SUBSURFACE WASTEWATER DISPOSAL SYSTEM APPLICATION

PROPERTY LOCATION	
City, Town, or Plantation	Augusta
Street or Road	182 Spring Road
Subdivision, Lot #	M11/L213
OWNER/APPLICANT INFORMATION	
Name (last, first, MI)	Olson, Martin <input checked="" type="checkbox"/> Owner <input type="checkbox"/> Applicant
Mailing Address of Owner/Applicant	182 Spring Road Augusta, ME 04330
Daytime Tel. #

Subject: Approval, **AFTER THE FACT**, Replacement System Variance Request, Martin Olson Property, 182 Spring Road, Augusta, Maine. Mailing Address Owner/Applicant: Same.

We have completed our review of an HHE-200 Form dated 03-27-2013 for the property at 182 Spring Road, Augusta, Maine.

DISPOSAL AREA CROSS SECTION

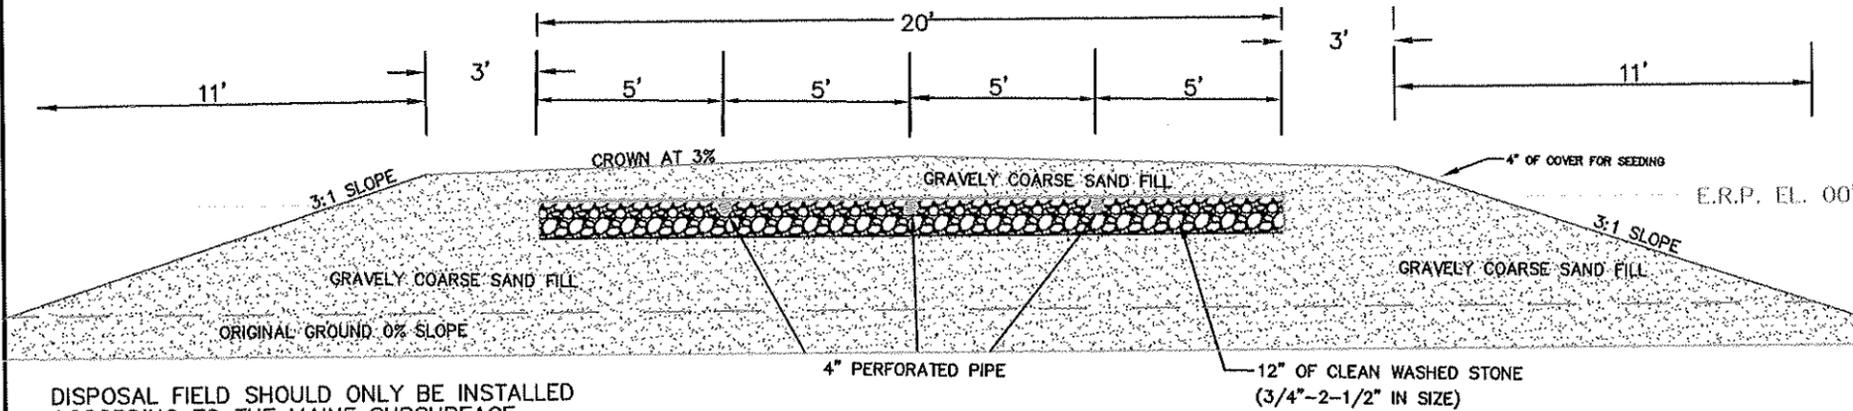
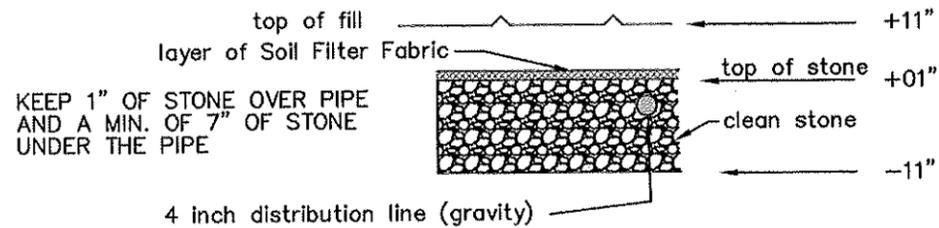
The variance request that is not within the LPI's authority is from the disposal field to the seasonal high water table of 0 inches.

The variance request that is within the LPI's authority is the fill extensions of 3:1 slope.

The contractor is to scarify the soils under the fill extensions to create a transitional zone more compatible with the disposal field area.
